## DESCRIPTIVE REPORT

Registry No. H-11001

# Descriptive Report to Accompany Hydrographic Survey H11001

Project OPR-P139-RA-00 Southwest Prince William Sound

*Figure 3. H11001 survey junctions*

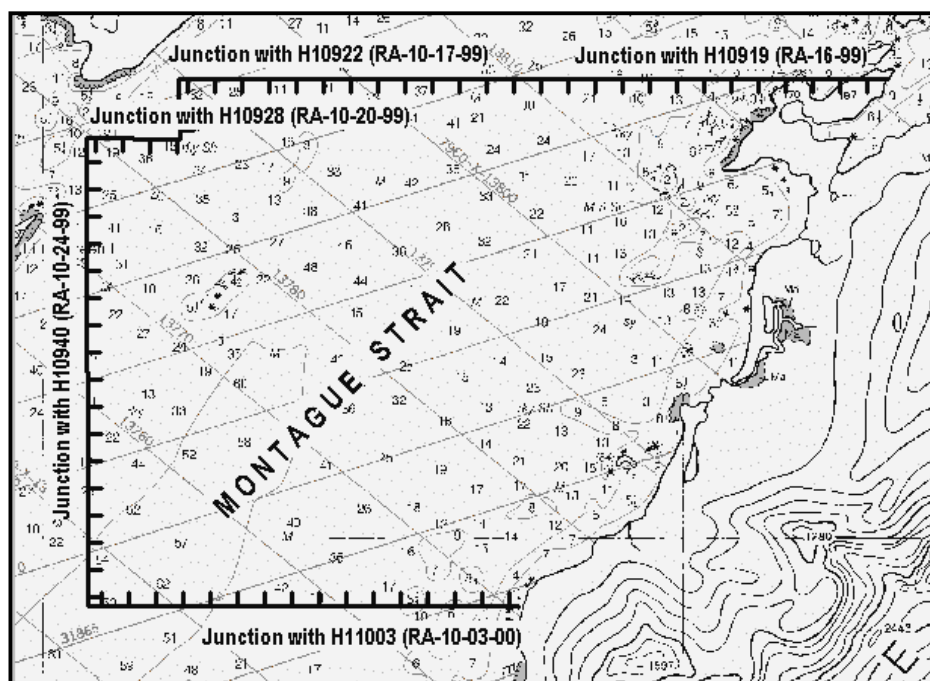
Contemporary surveys H10919, H10920, H10928, H10940 and H11003 junction well with H11001, with differences generally one half-fathom or less. <sup>5</sup>

<sup>5</sup> Concur
